Revised STAFF REPORT AND RECOMMENDATION TO THE DESIGN COMMISSION – Approval

CASE FILE: LU 15-259840 DZM
PC # 15-177695
1111 SE Sandy Blvd
REVIEW BY: Design Commission
WHEN: April 14, 2016, 1:30pm
WHERE: 1900 SW Fourth Ave., Room 2500A
Portland, OR 97201

The Burnside Delta project is proposed on a triangular 10,231 SF site at a Central City Gateway location – E Burnside and SE Sandy Blvd. The proposed building is 6 stories above a basement level built into the slope of the site which drops approximately 14' in approximately 200' on the E Burnside frontage. Approximately 2,500 SF of retail space is proposed on either end of the E Burnside frontage at SE Sandy Blvd and SE 11th Ave. 85 residential units are proposed on levels 1-6 and a community room and deck are proposed on level 6. Both residential lobby and garage access (approximately 18 vehicle parking spaces and 56 bike parking spaces) are proposed on SE 11th Ave at mid-block.

FLOOR PLAN - BASEMENT

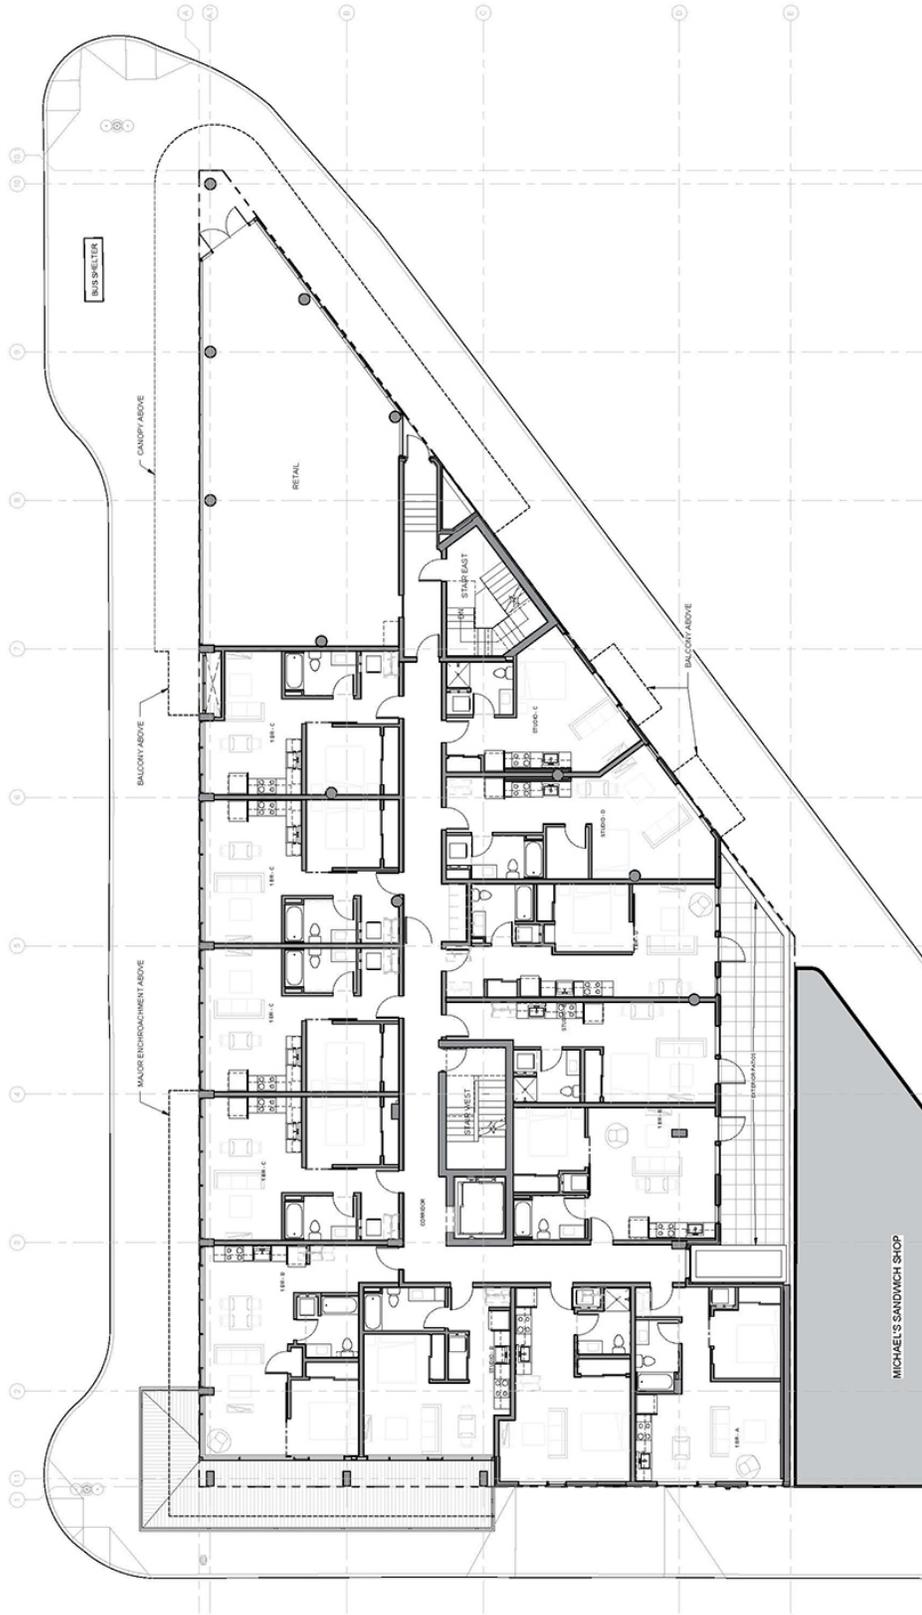
Findings: Although onsite parking is not required with redevelopment of this site, the proposal retains approximately the same number of stalls as are currently on the property. However, rather than a surface lot as currently exists, the proposal is for a partially below-grade parking garage accessed from SE 11th Avenue toward mid-block. This approach will not only improve the appearance of the site but will also allow for an interior although non-standard loading bay – the Standard B stall (9’Wx18’Lx10’H) is proposed to partially block an internal drive aisle which

requires a Modification to PZC 33.266.130 F.1.a, Parking Area Layouts requiring that parking areas be designed so that a vehicle may enter or exit without having to move another vehicle (Please refer to Modification #1 in Section 2 of this Staff Report). PBOT had indicated that prior to supporting this Modification, a Queuing Analysis shall be submitted. A queuing analysis has been submitted to PBOT's satisfaction. As such, Staff determines that the parking layout as proposed will be operationally supportable. *Therefore, this guideline is met.*

Findings for Modification 1: The applicant proposes one on-site loading space within the at-grade parking garage intended to serve truck loading demands associated with apartment move-in/outs. The entrance to the parking garage will be provided by a 20-foot wide driveway along SE 11th Ave, approximately 60 feet south of the extended curb line on E Burnside St. The entrance will include a sectional security gate located 12 feet from the finished curb line.

Findings: The modification to reduce the width of 6 of the 18 garage parking spaces from 8'-6" to 7'-9" due to required structural column layout is in keeping with other parking garages of this type. The remaining parking spaces will be a minimum of 8'-6" wide. The drive aisles and other maneuvering spaces as well as bike parking, stairways, ADA parking spaces, and pedestrian walkways will comply with code requirements so that vehicles can enter and exit as well as pass each other within the parking garage in a safe manner.
